CITY PLAN COMMISSION STAFF REPORT

East Campus Office & Manufacturing MPD Plan

CD-CPC-2023-00150 – Rezoning with Plan

Plan Conditions

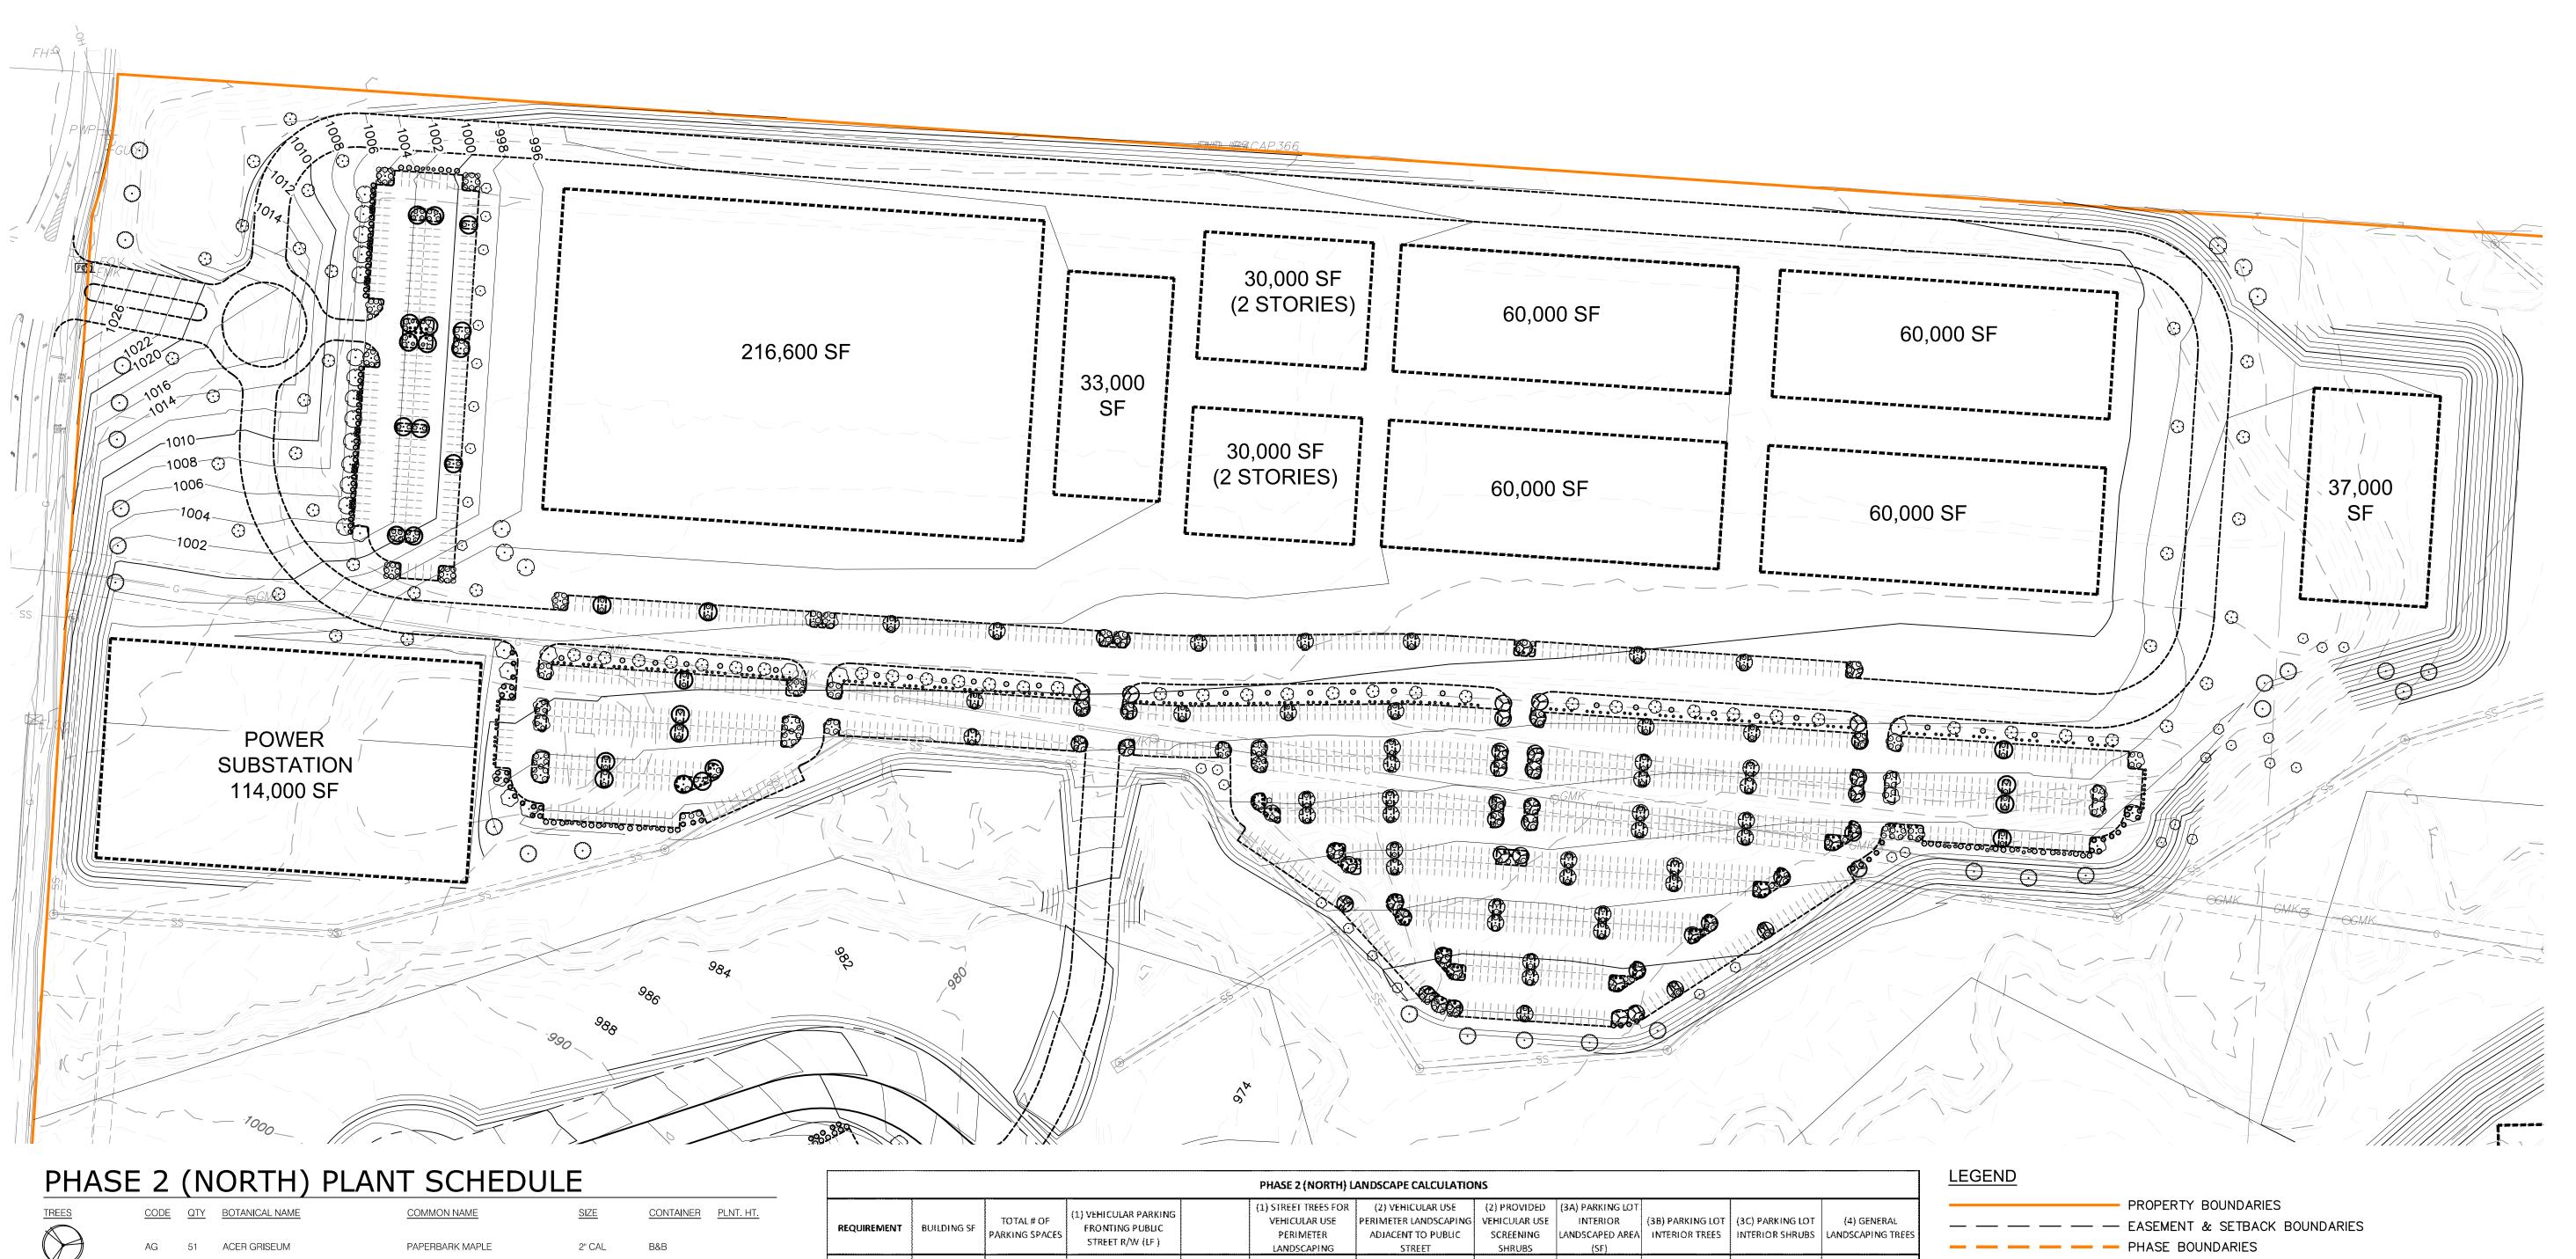
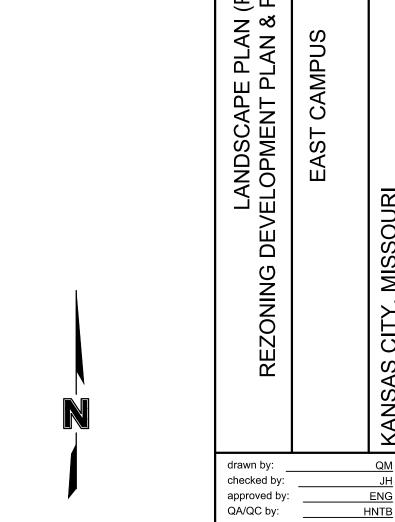
The applicant has submitted a preliminary landscape plan to allow staff to review compliance with 88-405-05-F and 88-425-04-B of the Zoning and Development Code. Staff recommends the applicant revise the landscape plan with emphasis on the proposed vehicular use along the public roadway (150 Hwy). This can be accomplished with berms and evergreens.

The applicant submitted a preliminary landscape plan. Staff recommends submittal of a revised landscape plan per staff approval prior to ordinance request to ensure that the vehicular uses proposed along 150 Hwy are adequately screened. OA
